# FOUNDATION REPORT

# WYNOOCHEE DAM

CENPD-EN-G (CENPS-EG-G/8Jul88)(1130-2-320b) 3rd End Munger (503)326-3867  
SUBJECT: Wynoochee Dam Foundation Report, 1988

SUBJECT: Wynoochee Dam Foundation Report, June 1988

U. S. ARMY ENGINEER DISTRICT, SEATTLE				
CORPS OF ENGINEERS				
SEATTLE, WASHINGTON				
FOUNDATION REPORT				
DIVERSION SLOPE LAYBACK-				
MONOLITH 6				
WYNOOCHEE DAM				
WYNOOCHEE RIVER		WASHINGTON		
SIZE	INVIATION NO	FILE NO	DATE	PLATE
D		E-57-6-4	DEC87	11
DRGN	ECKERLIN	CHK	GALSTER	SHEET

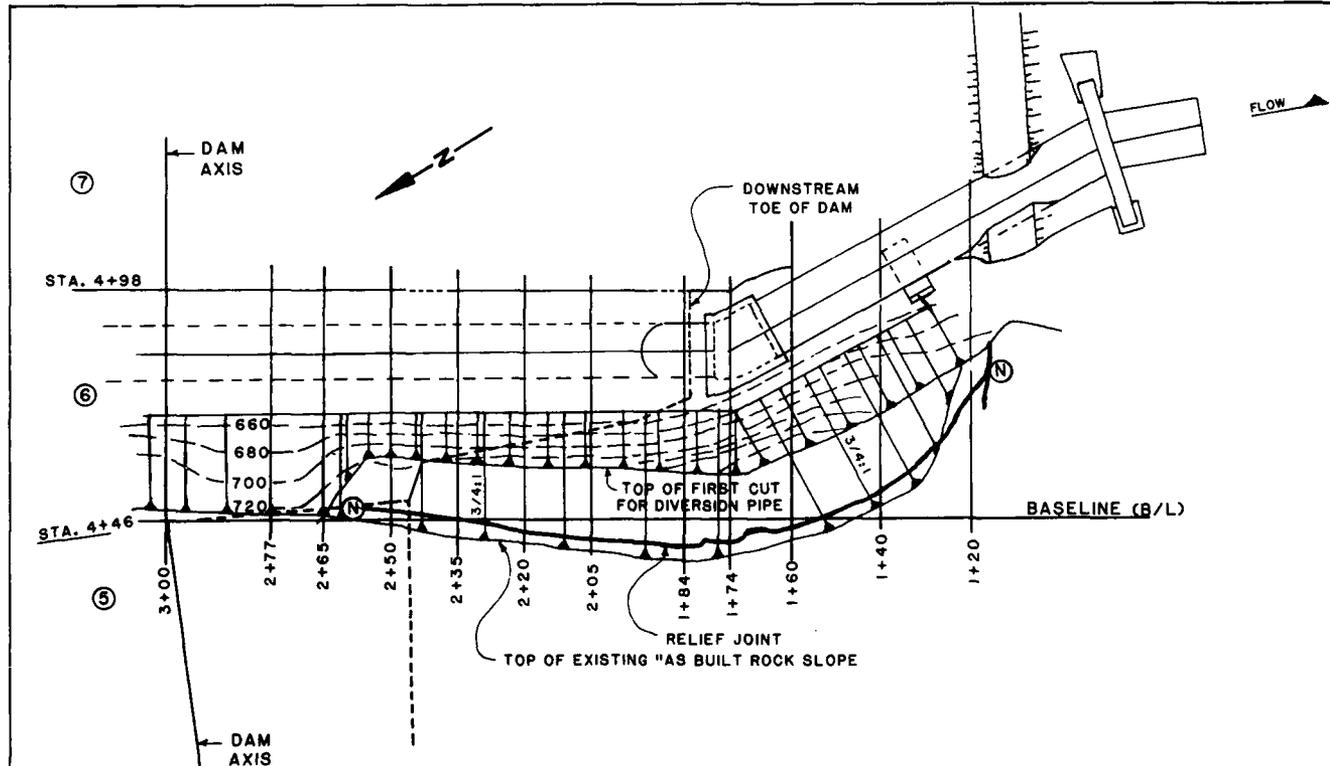
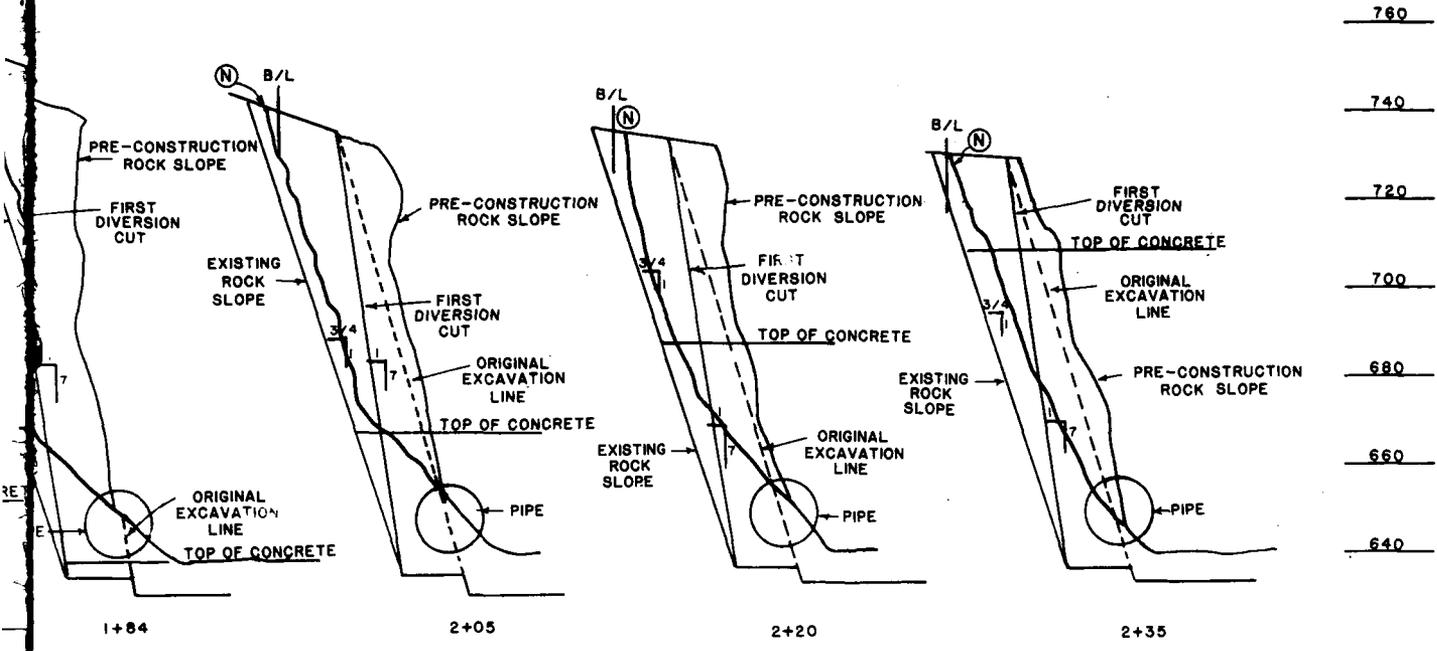
e. There are no plates that show excavation drawings for the structure, other than monoliths 6 and 7 (Plates 11 and 12). If this information is available, it should also be added to the report.

- e. There are no available plates that show as-built excavation drawings for the structure other than what is already included in the foundation report.

WYNOOCHEE RIVER		WASHINGTON		
SECTION	INVITATION NO.	FILE NO.	DATE	PLATE
D		E-57-6-4	DEC67	14
DESIGNER	ECKERLIN	ENGINEER	GALSTER	SHEET

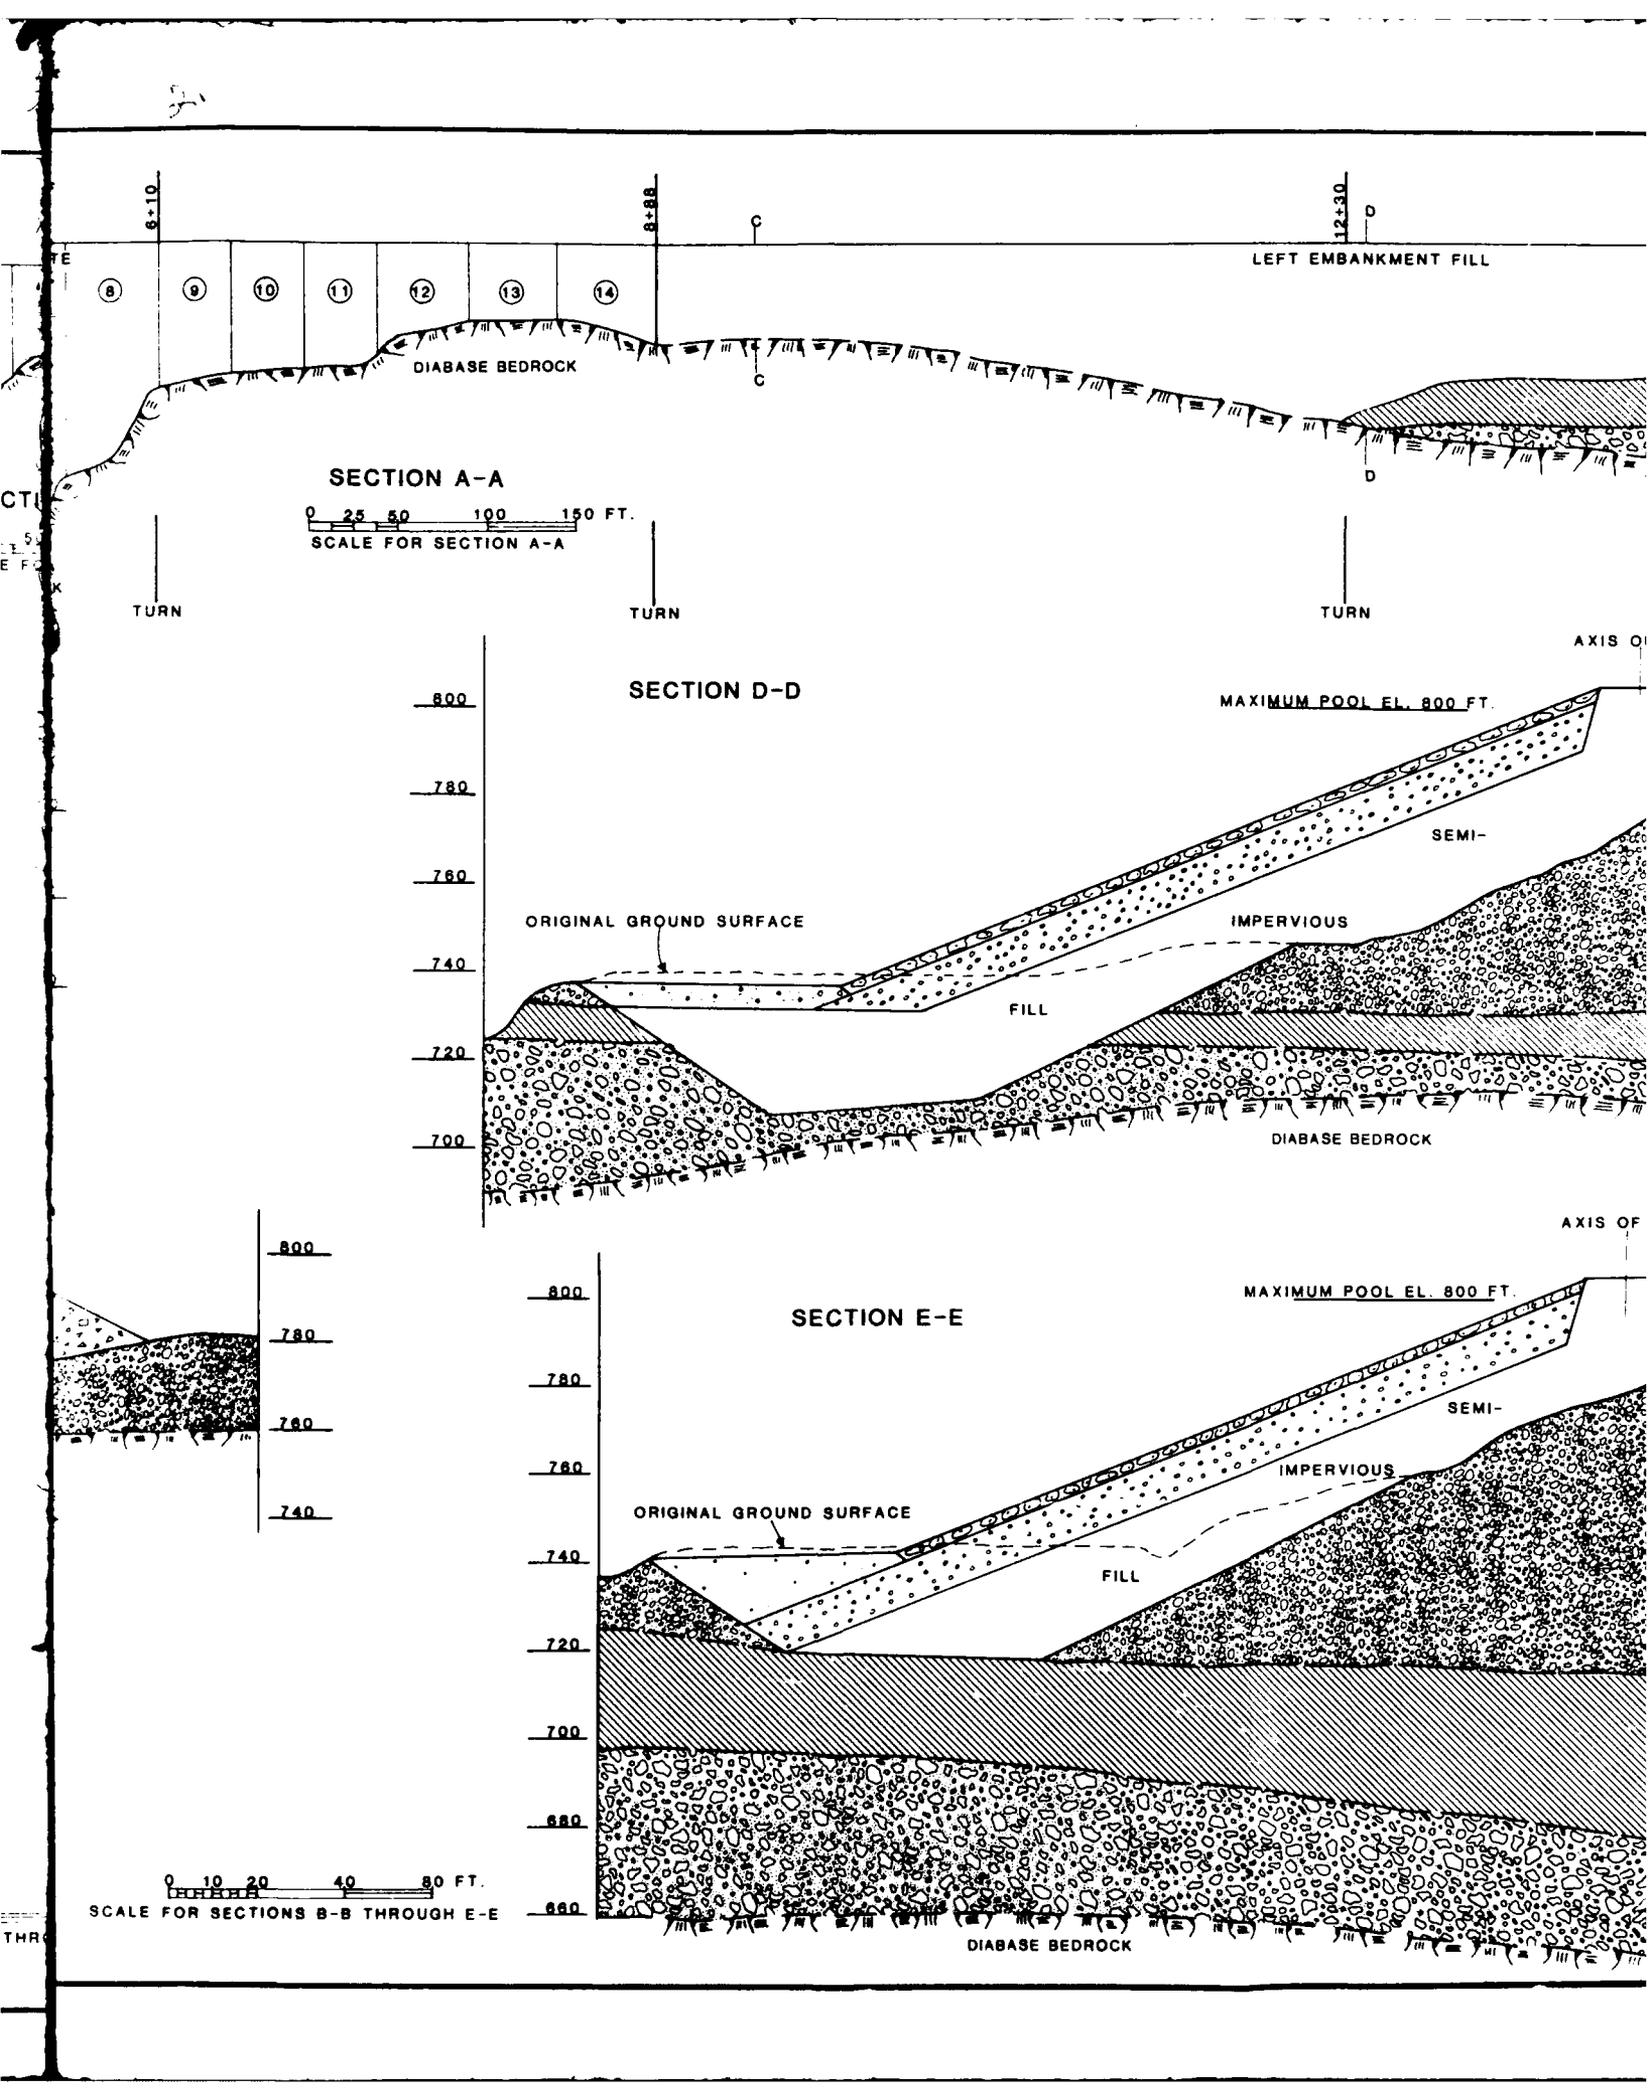
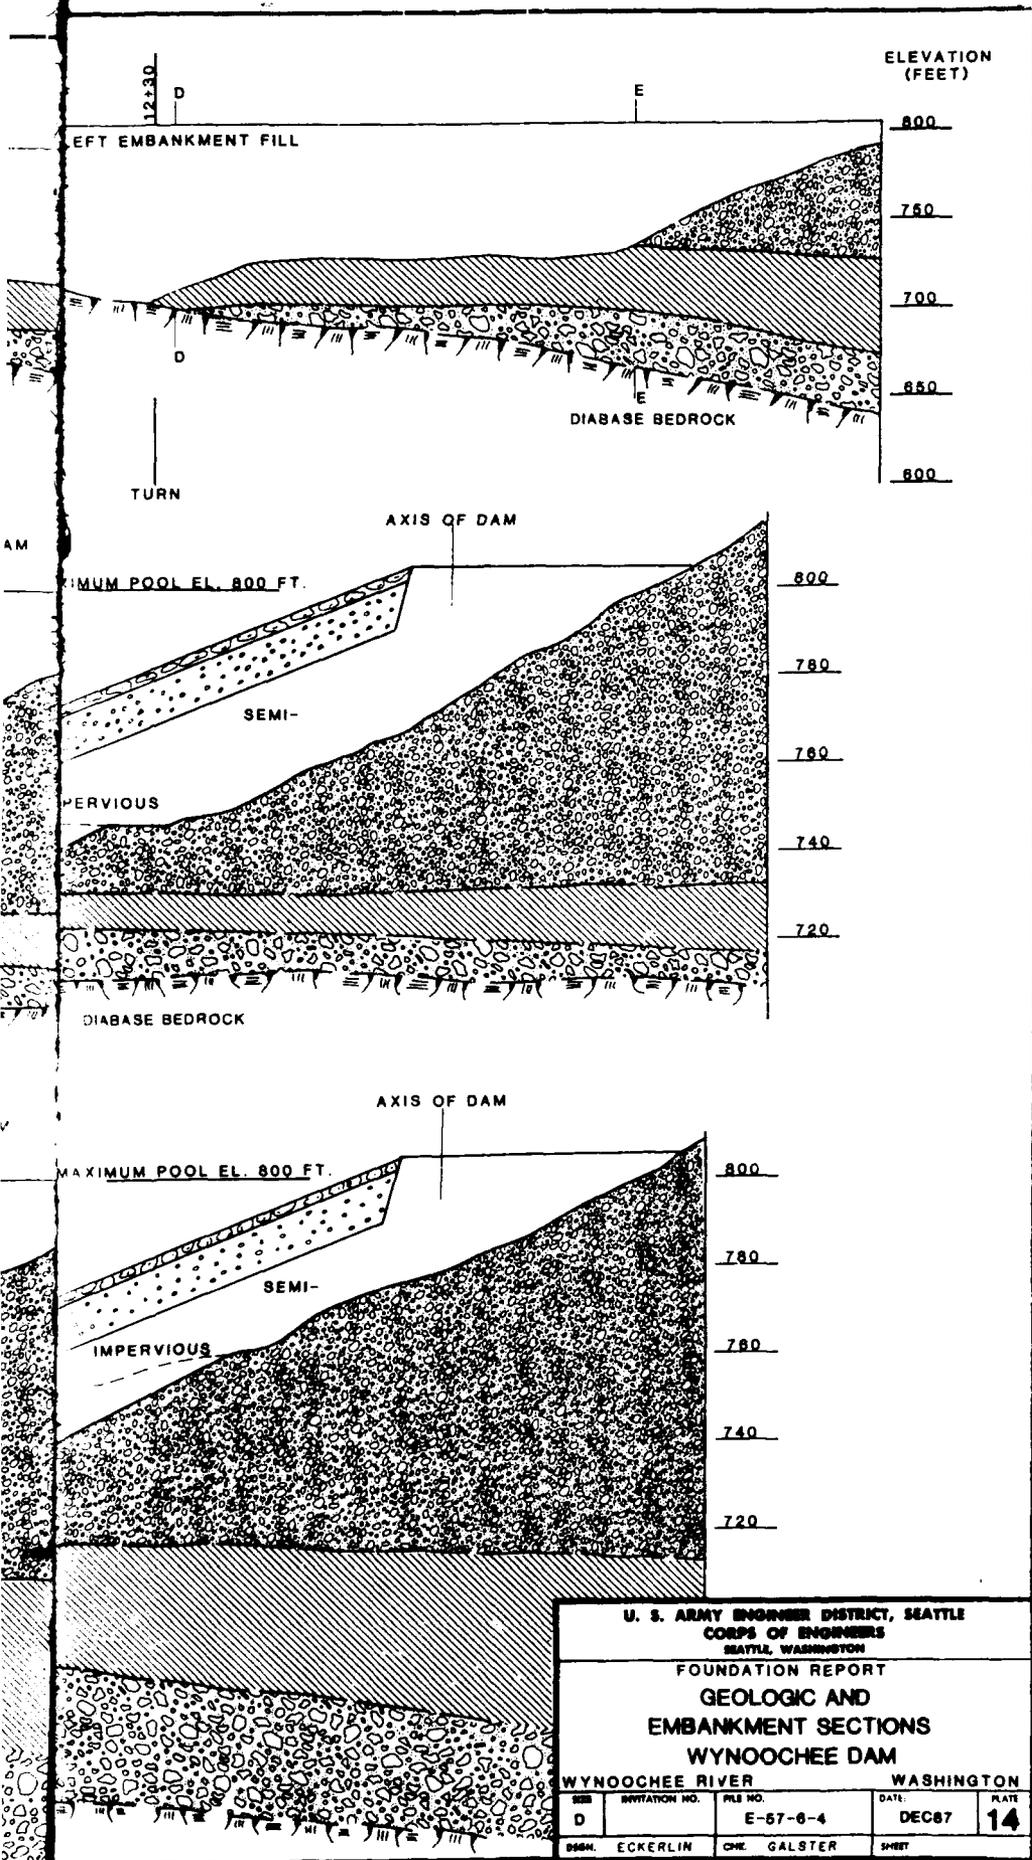
d. There are no plates that show "as mapped" geologic sections, such as a centerline profile or abutment slope mapping sections. If such data exists, it should be added to the report.

- c. Concur
  - d. There are no plates available that show "as mapped" geologic sections. Plate 14 in Appendix B presents geologic and embankment sections that have been compiled using data interpreted from other drawings in this appendix.
